Service Bulletin

Bulletin No. 2005-03

30-60 EFI FourStroke Fuel Cooler Hose Replacement

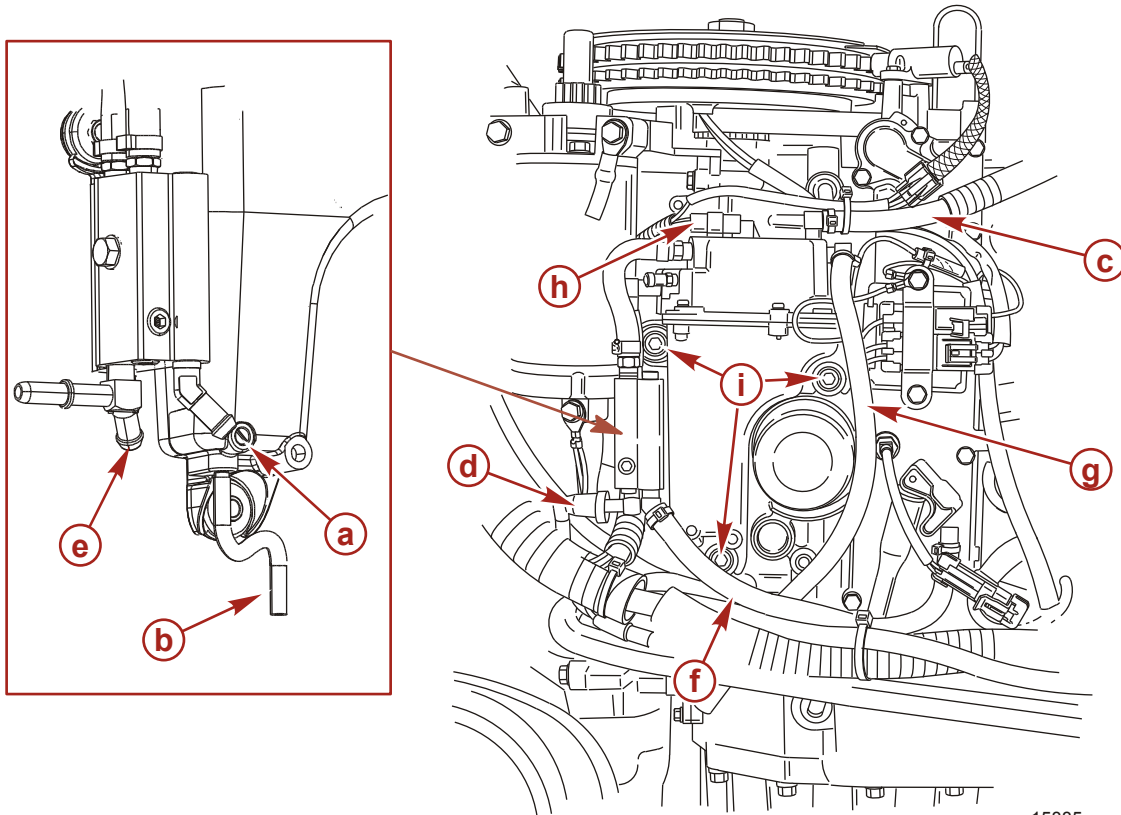
The engine models listed above are at risk to have the fuel cooler water return hose damaged by the cowl mounted trim switch. Mercury Marine has installed protective sleeves on all production built product after serial number 1B101240 to prevent the trim switch from damaging the hose.

Install the new hose and protective sleeve to prevent this damage from occurring on the above mentioned models.
